ADDENDUM NO. 4**DATE: July 20, 2026**

PROJECT: HARMONY SCIENCE ACADEMY BRIDGELAND PHASE II MIDDLE-HIGH SCHOOL

**ARCHITECT'S PROJECT
NUMBER:** 06-22-014

AlumiSet® Carrier System
Item 2 - Type B - Office/Classroom Identification
AL-CM-GP2-GP6-LAM-5-5-7-5-TS
2010 ADA-SAD

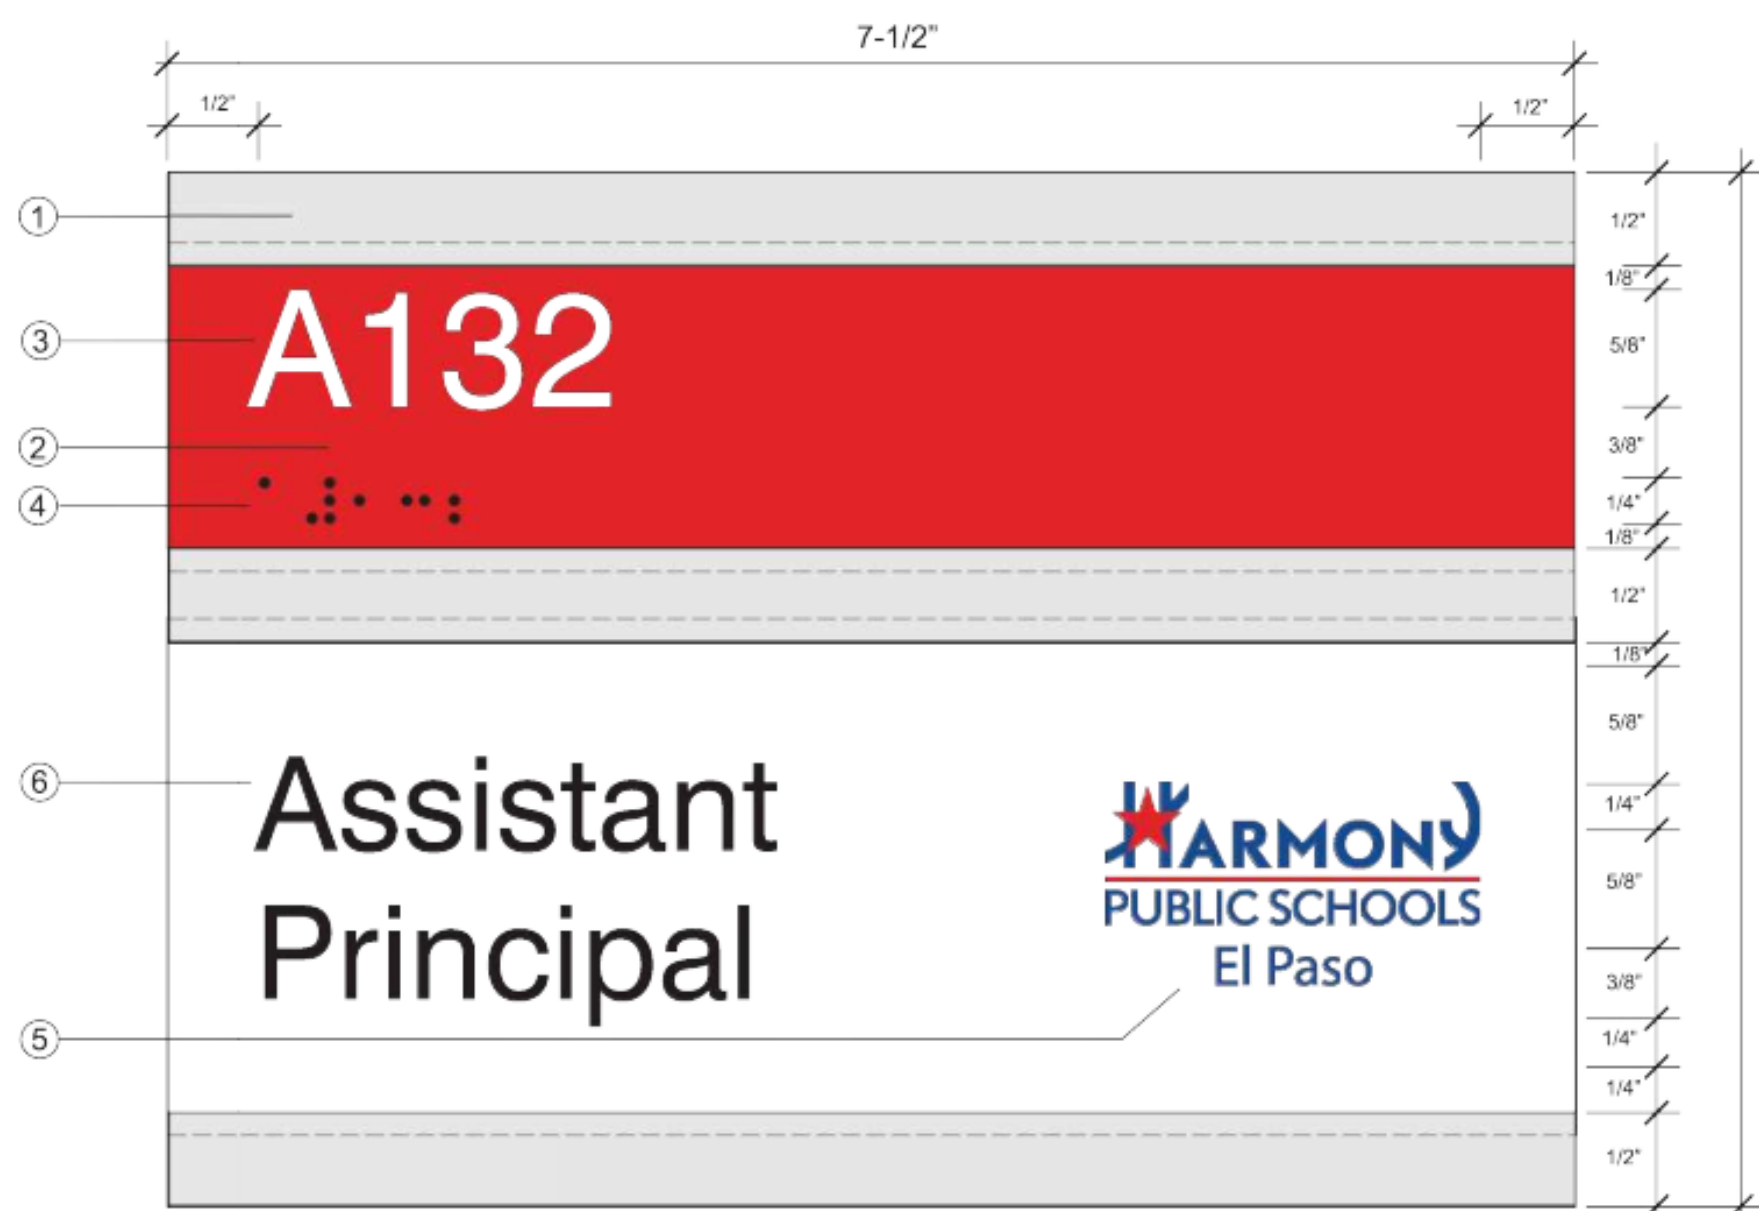
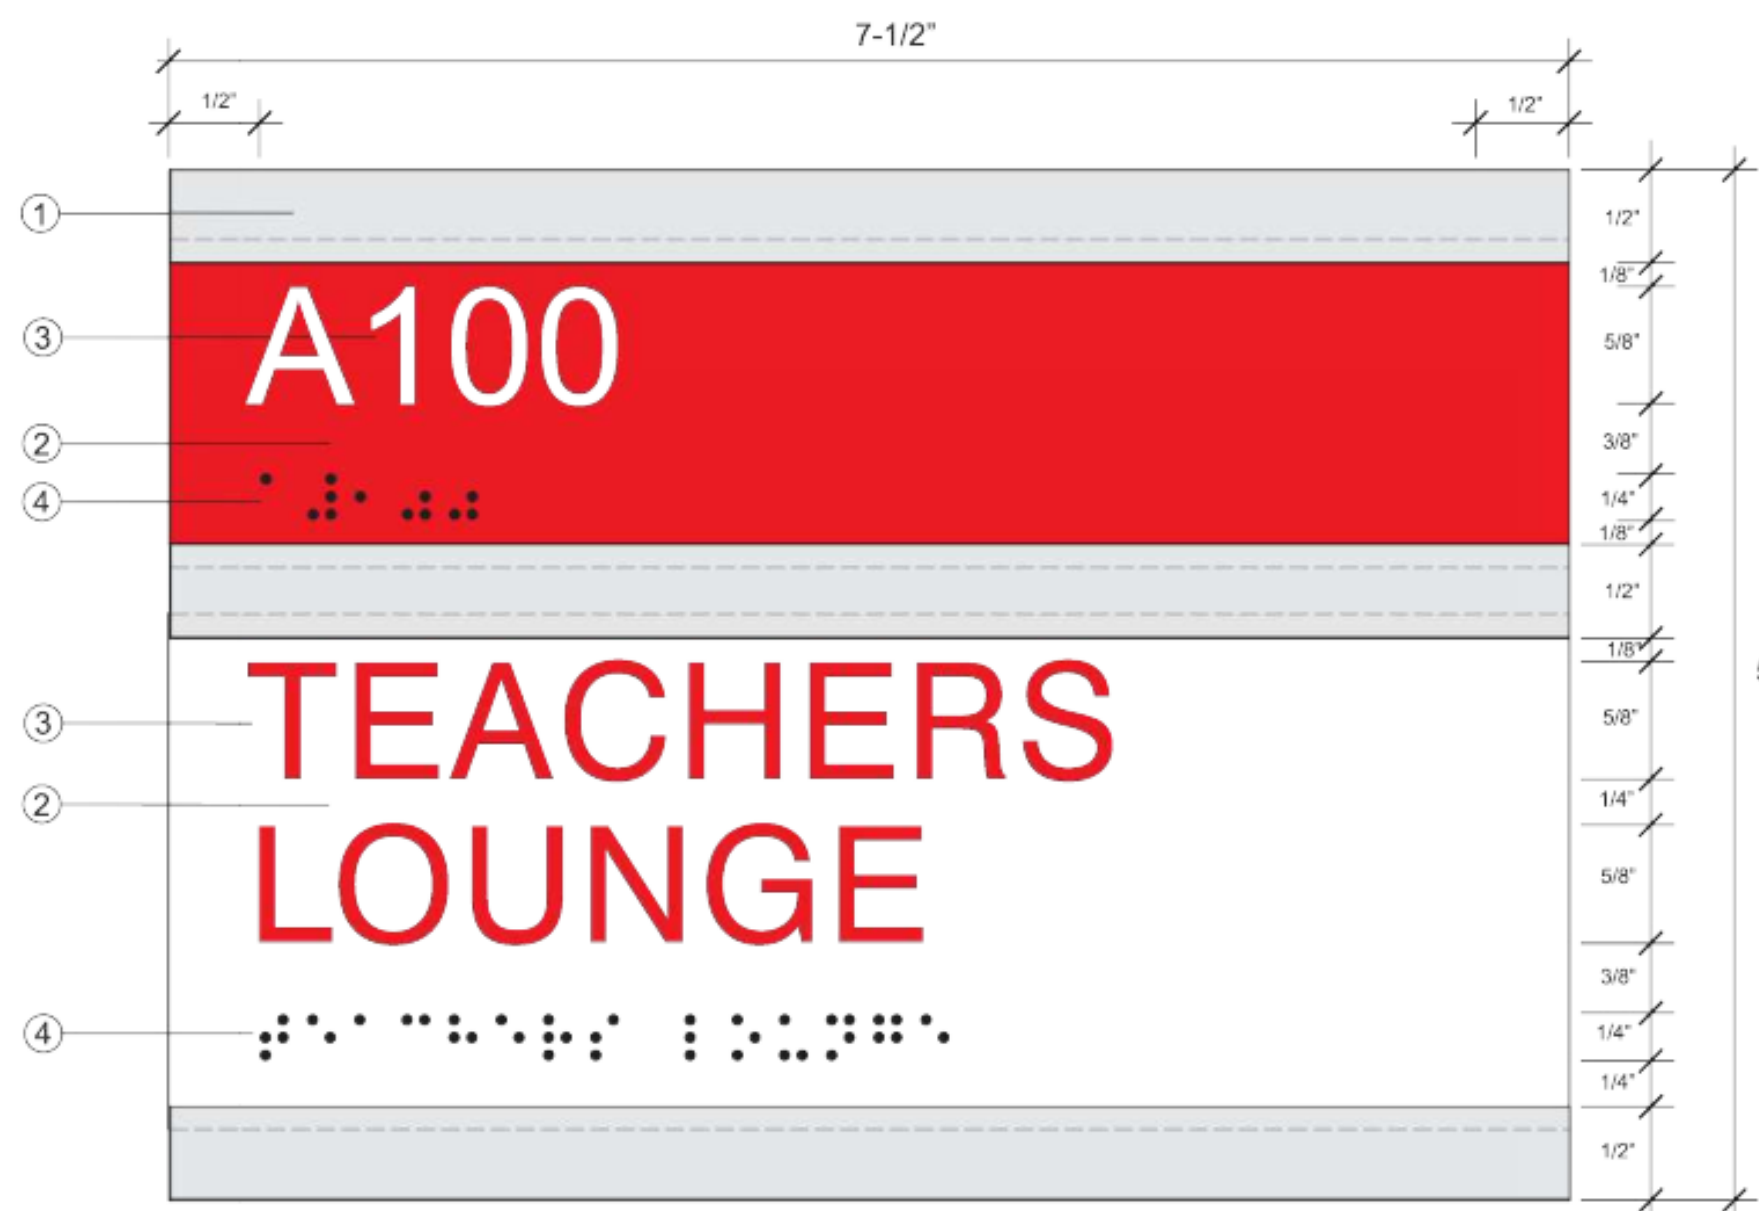
49. *The project documents do not include a signage floor plan identifying sign types by room location. To accurately quantify and price the required signage, please provide a signage floor plan indicating each sign type and its corresponding room/location throughout the project.*

Response: The signs shown on sheet A-821 have been labeled Type A, Type B, and Type C. Type A is typical of all restroom locations. Type B is typical of all offices. Type C is typical of all Classrooms, Teachers Lounges, and all other rooms.
